Project	<b>IEEE 802.16 Broadband Wireless Access Working Group</b> < <a href="http://ieee802.org/16">http://ieee802.org/16</a> >	
Title	RS Initial Network Entry	
Date Submitted	<b>2007-01-16</b>	
Source(s)	<p>Hang Zhang, Peiyong Zhu, Mo-Han Fong, Wen Tong, David Steer, Gamini Senarath, Derek Yu, Mark Naden, G.Q. Wang</p> <p>Nortel 3500 Carling Avenue Ottawa, Ontario K2H 8E9</p> <p>Kanchei (Ken) Loa, Yi-Hsueh Tsai, Shiann-Tsong Sheu, Hua-Chiang Yin, Chih-Chiang Hsieh, Yung-Ting Lee, Frank C.D. Tsai, Heng-Iang Hsu, Youn-Tai Lee</p> <p>Institute for Information Industry 8F, No. 218, Sec. 2, Dunhua S. Rd., Taipei City 106, Taiwan, ROC.</p>	<p>Voice: +1 613 7631315 <a href="mailto:wentong@nortel.com">[mailto:wentong@nortel.com]</a></p> <p><a href="mailto:pyzhu@nortel.com">[mailto:pyzhu@nortel.com]</a></p> <p><a href="mailto:loa@nmi.iii.org.tw">loa@nmi.iii.org.tw</a></p>
Re:	A response to a Call for Technical Proposal, <a href="http://wirelessman.org/relay/docs/80216j-06_027.pdf">http://wirelessman.org/relay/docs/80216j-06_027.pdf</a>

# RS Initial Network Entry

Figure 1. Proposed RS network entry.

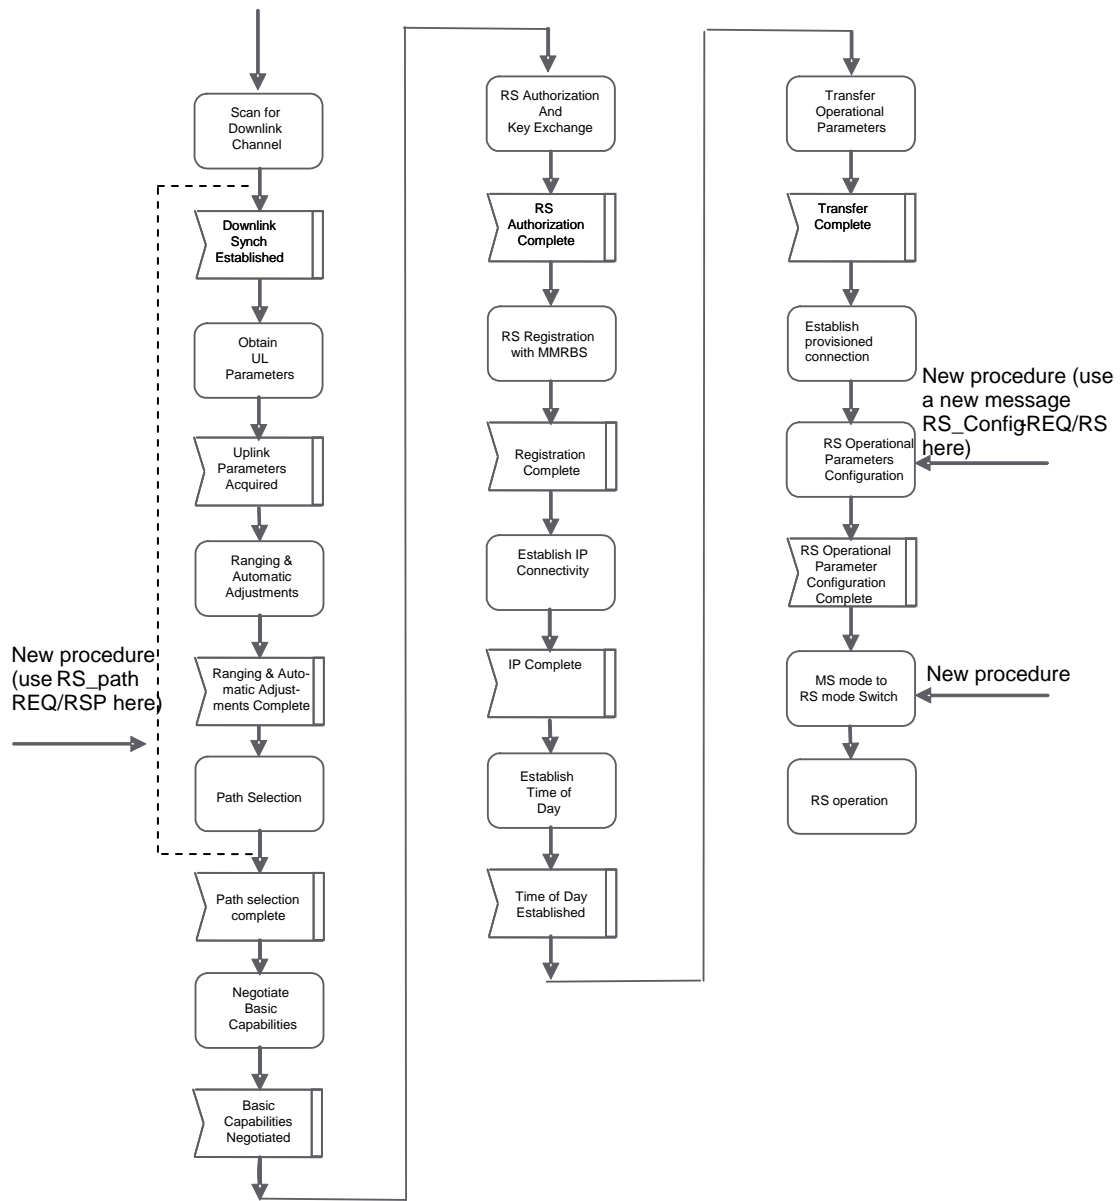
We propose the RS initial network entry as shown in Figure 1. Compared with MS initial network entry, three operation steps are added:

- Access point attachment (path) negotiation  
This procedure enables a RS and the MRBS to negotiate the initial access point attachment of this RS. This operation happens after UL parameter automatic adjustment complete and before basic capability negotiation. During this operation a relay station is allowed to report to the MRBS the radio environment measurements. The MRBS is allowed to make final decision regarding the access point attachment selection (e.g., serving station selection). In order to support this operation, we suggest either reuse RNG-REQ/RSP message with a new TLV added in RNG-REQ message or introduce a new message called as RS\_path request/response. The benefit by putting this procedure right after the ranging is to avoid path update after the initial network entry since the path update requires certain signaling exchanges between MRBS and RSs in the path

- Relay station operation parameter configuration  
This procedure allows a RS to obtain necessary operation configuration parameters that must be configured over-the-air. One example of such parameters is the frame beginning preamble (802.16e preamble) configuration since the configuration of such parameters usually requires radio environment measurement of a RS. To enable this procedure, we suggest to introduce a new MAC management message – RS configuration request /response message (RS\_Config-REQ/RSP).

- MS mode to RS Mode Switch  
At mode switch action time (the action time is negotiated during the relay station operation configuration procedure), a RS starts the RS normal operation.

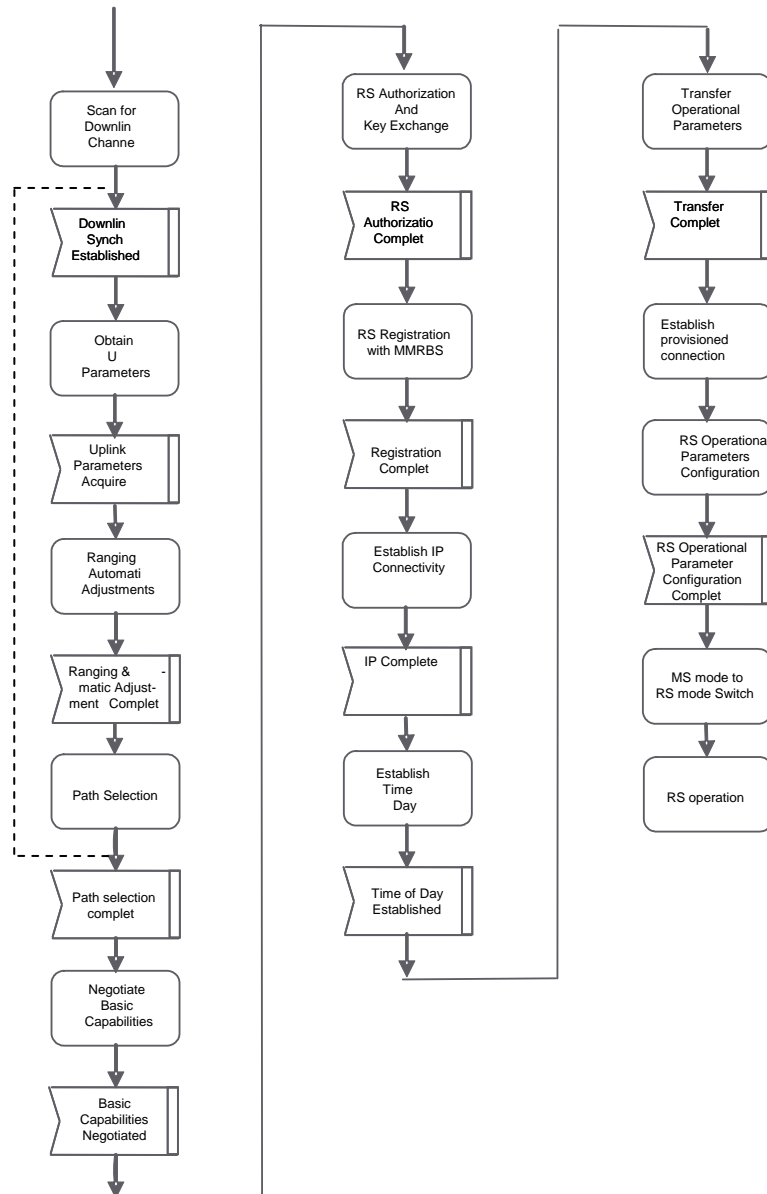
RS network entry procedure is shown in Figure xxx.

From this figure, three new procedures are added to RS network entry procedure. They are path selection negotiation, relay station operational parameters configuration and MS to RS mode switch.
